Service letter

SL: 40034
Date: 14 June 2017
Product: Compressor generator option
Subject: Residual current device (RCD)

Picture 1

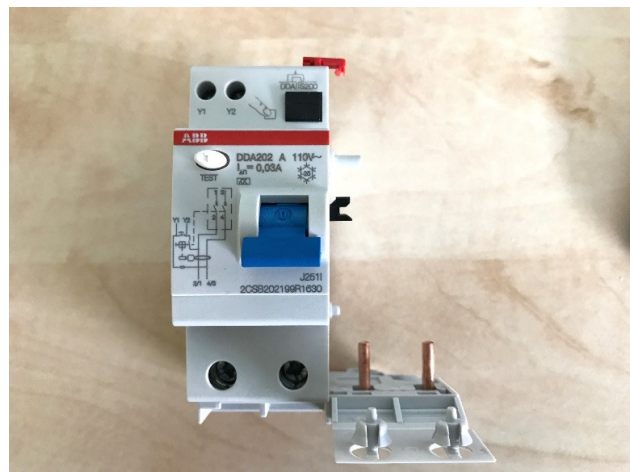
Residual current device manufacturer has changed his product Art. No 2CSB202001R1630 type DDA202 AC $I_{\Delta n}$ 0,03A at the end of 2015.

Since that time new product is available with the same ABB Art. No. but it is no more usable for 110 V generators.

New product Art. No 2SCB202199R1630 is intended for use in 110V generator option only. CPN 46501896 rev. C See picture 1

Picture 3

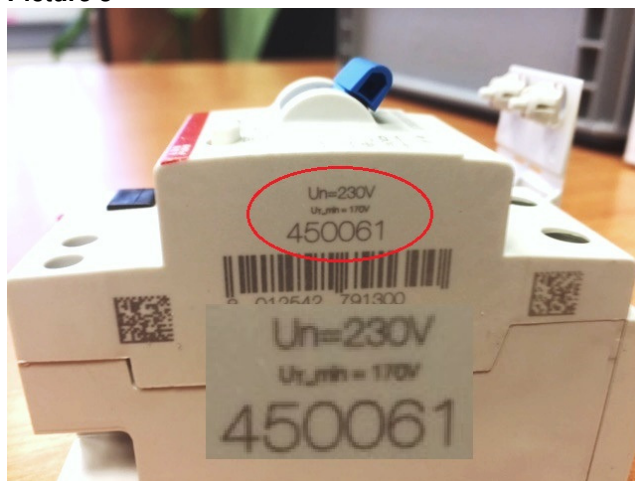
Don't use

Art. No. 2CSB202001R1630 if marking on the side shows $U_n=230V$

$U_{T_min}=170V$
